6-16 West 77th Street New York

Landmarks Preservation Commission Updated Presentation
May 3rd 2022

LPC Design Recommendations

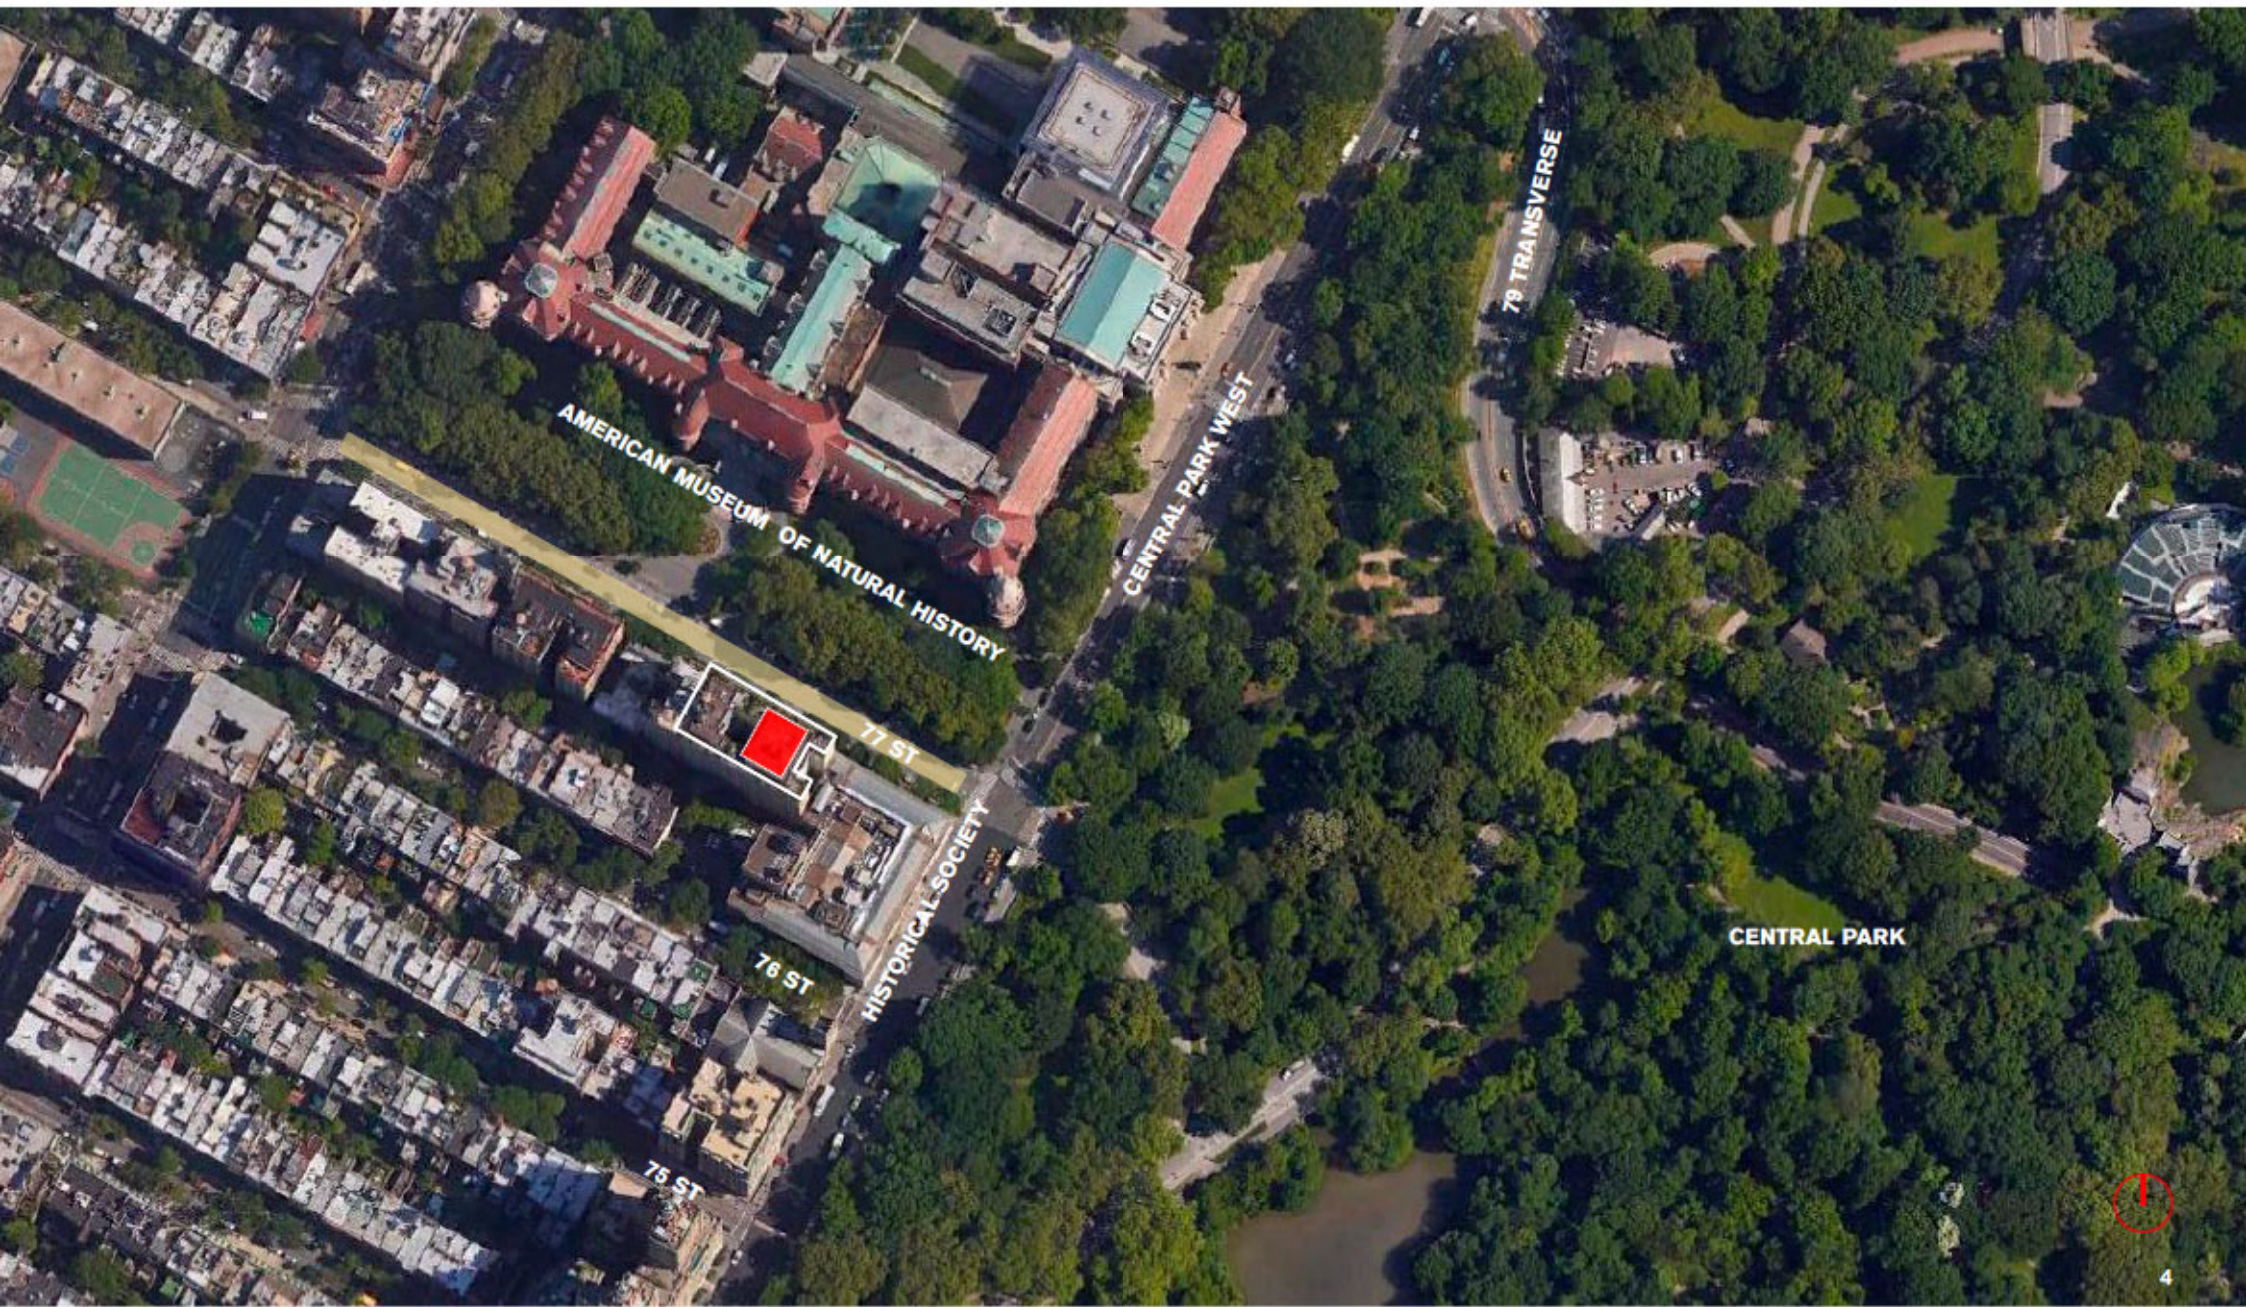
- Reduce visibility of the level 18 enclosure
- Restudy the colour of the cladding

- Remove occupied space on level 18
- Reduce the height and footprint of level 18
- Propose a less contrasting cladding color

Pavilion Architecture: Revised Materiality

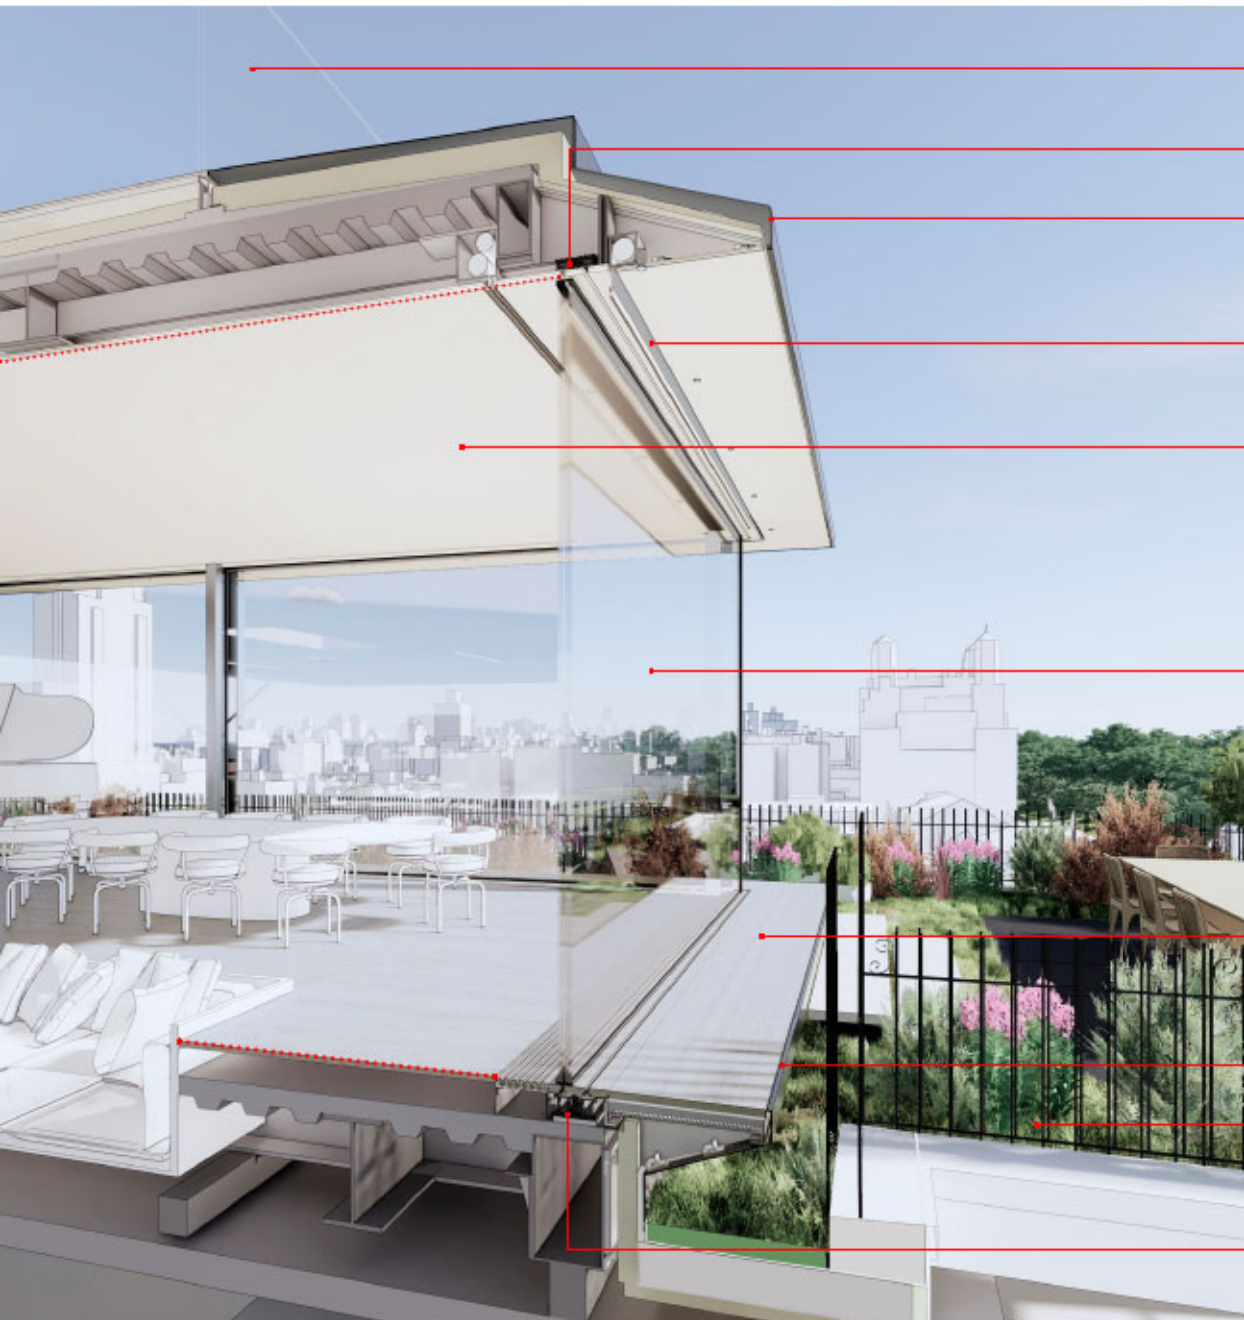
Cladding
- Blackened Stainless Steel

Cladding
- Neutral Grey Metal Cladding
- Brushed / Matte Finish

Level 18 - Comparison

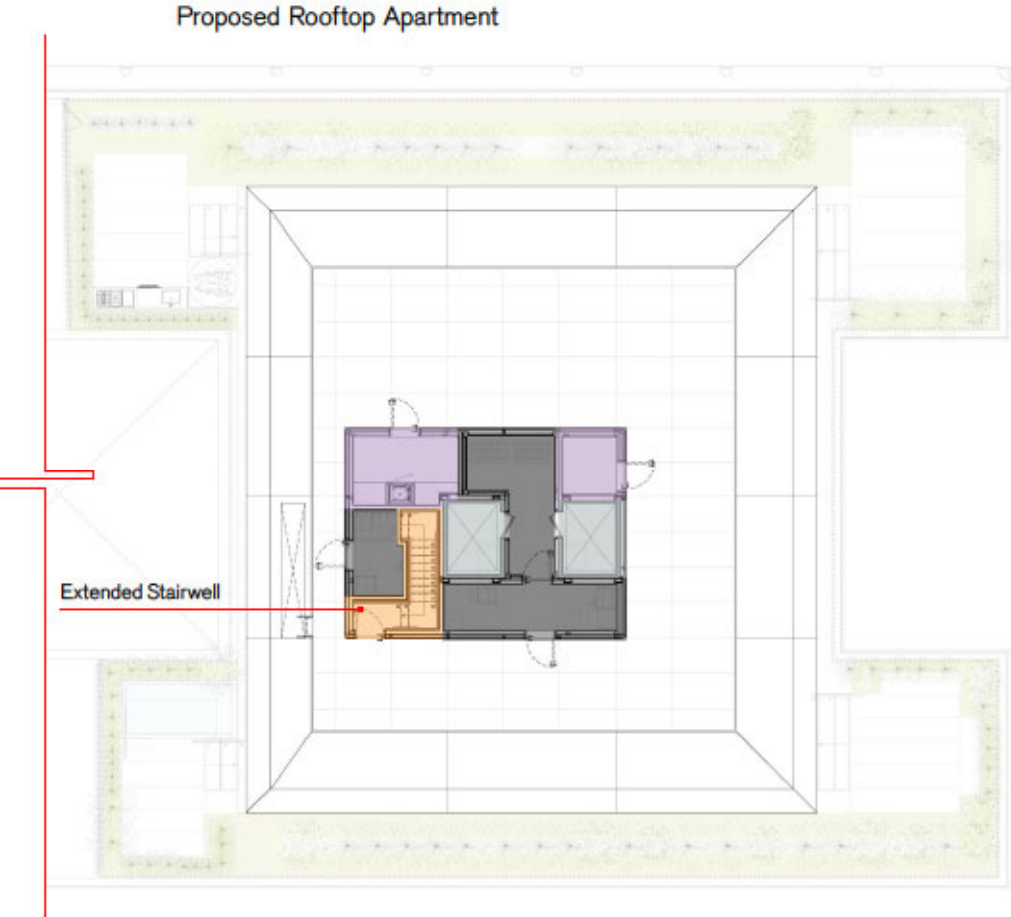
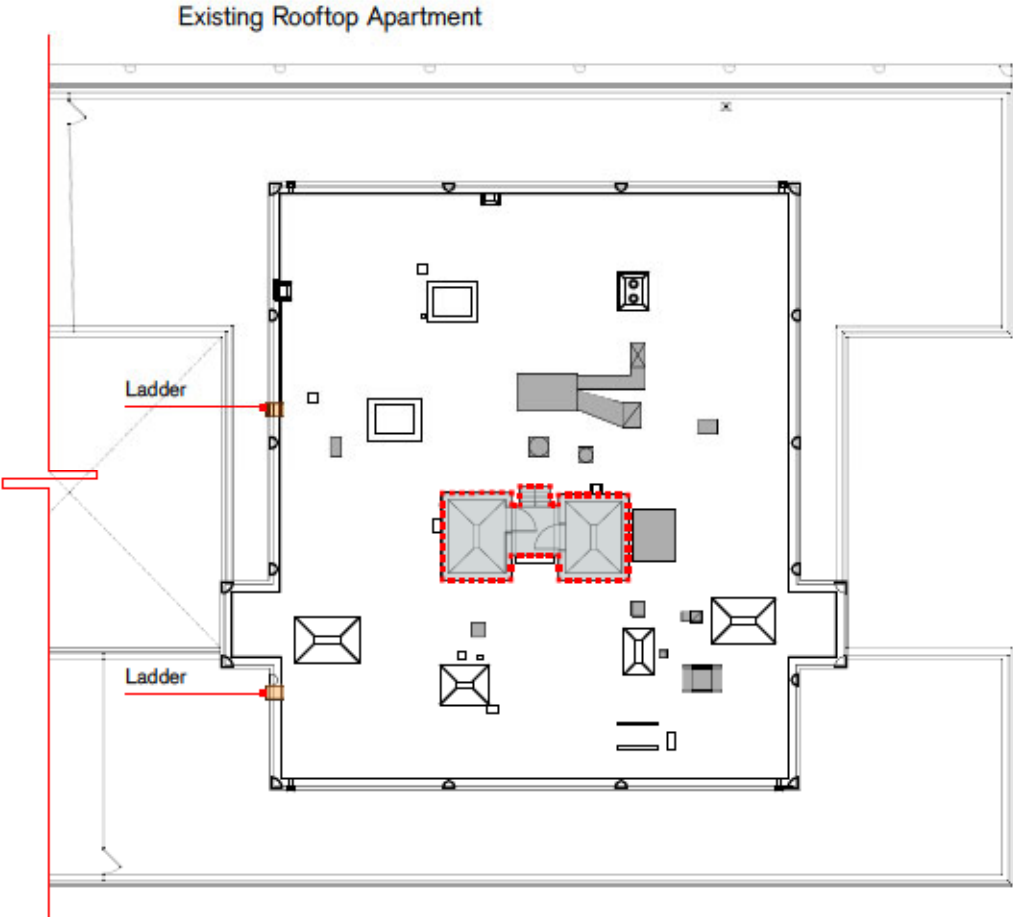
- Existing Outline
- Proposed Footprint
- Relocated Floor Area (MEP + Reduced Footprint)
- Life Safety
- MEP
